Sent: 13/12/2020 9:13:03 PM
Subject: Local Planning Panel Submission - DA2020/0824- 321 to 331 Condamine Street
Attachments: Planning letter copy v3.pdf;

Northern Beaches Council Planning Panel - DA2020/0824 - 321-331 Condamine St, Manly Vale

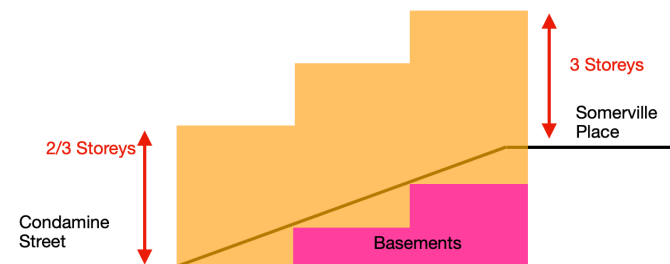
This mischaracterises development between King St and Kenneth Rd. Whilst the buildings along Condamine Street have four levels, due to the rising topography and setbacks, there is typically no more than 3 storeys as illustrated to the right.

It's unreasonable to use these compliant 4 storey buildings as justification for a non-compliant 4 storey design. Reviewing the developments from south to north from Kenneth Rd:
